GAROB WIND ENERGY FACILITY ON A SITE NEAR COPPERTON, NORTHERN CAPE PROVINCE

DEA ref: 14/12/16/3/3/2/279

MOTIVATION FOR AMENDMENT OF ENVIRONMENTAL AUTHORISATION

Figure 1: Locality map showing the layout for the Garob Wind Farm Facility

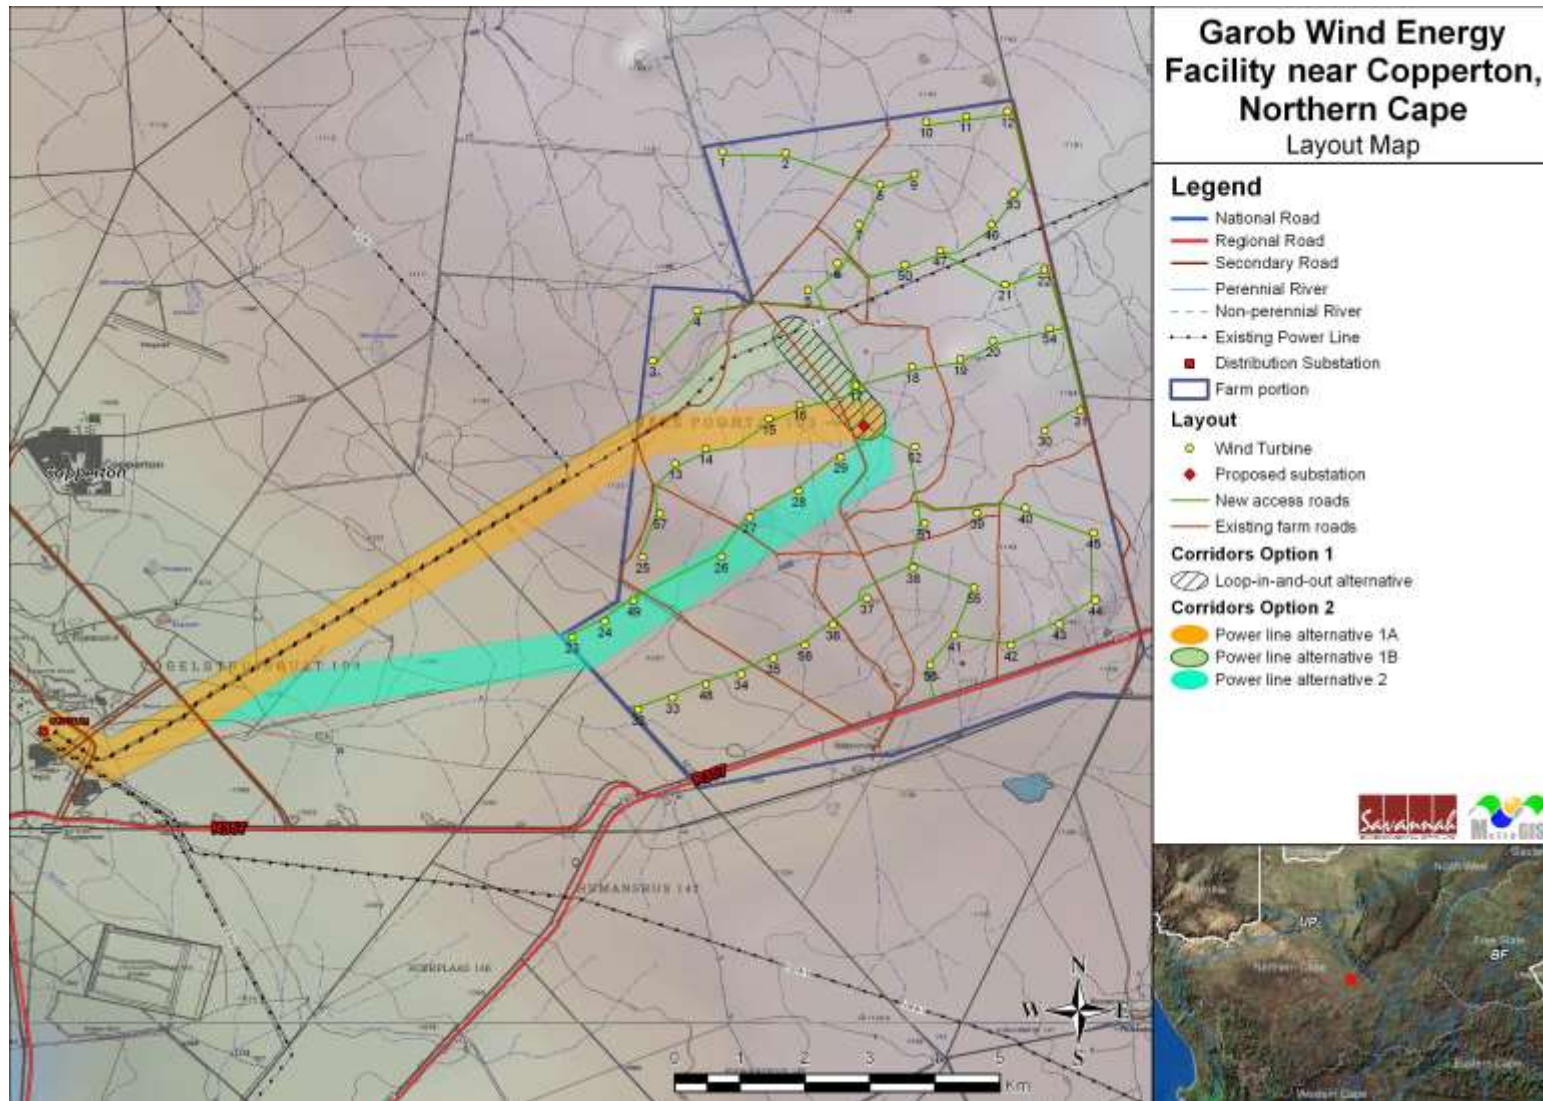
In terms of the environmental authorisation, the project description referred to wind turbines with a hub height of up to 100m and a rotor diameter of up to 120m. Following recent developments in technology and availability of turbine options for the project, Garob Wind Farm (Pty) Ltd would like to request an amendment to the already received Environmental Authorisation so as to increase the allowable rotor diameter from the authorised 120 meters to 125 meters. This will enable the developer to install a technology on the site which is best suited to the conditions on the site (and will increase the efficiency of the facility). This amendment will not result in a change in extent of the facility footprint (see Figure 1).

- » Wind turbines with a hub height of up to 100m and a rotor diameter of up to **125m**.
